RE: Application for Permit to Drill-  
PPCo 30-605, NW/4 NW/4 Sec.30  
T16S, R09E, SLB & M, Emery County, Utah

**APPLICATION FOR PERMIT TO DRILL OR DEEPEN**

WORKSHEET  
APPLICATION FOR PERMIT TO DRILL

**DIVISION OF OIL, GAS AND MINING**  
**APPLICATION FOR PERMIT TO DRILL**  
**STATEMENT OF BASIS**

## Casing Schematic

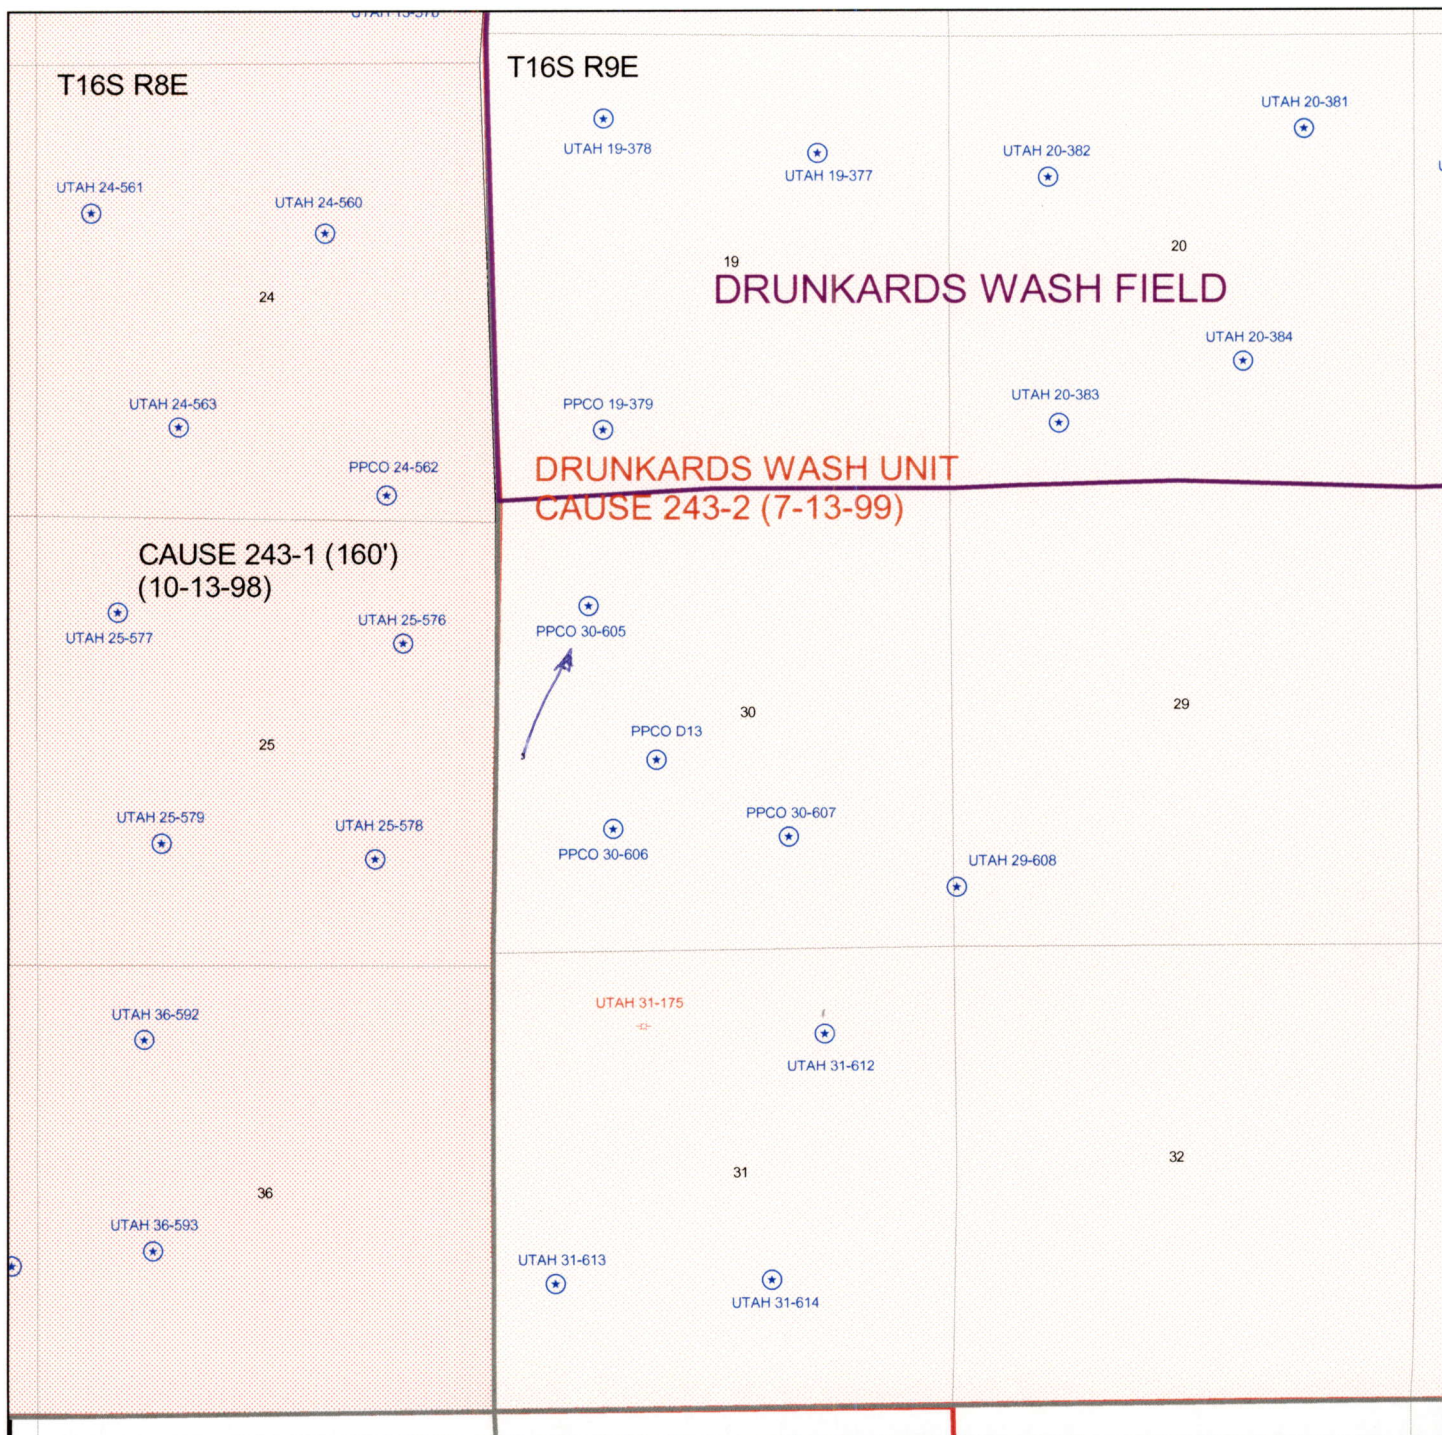
$$\frac{240}{0.052} \times 8.4 \times 3080 = 1345 \text{ psi}$$

Anticipated = 1334 psi

$$0.12 \times 3080 = 370 \text{ psi}$$

$$\text{MASP} = 975 \text{ psi}$$

3m BOPE proposed

Adequate
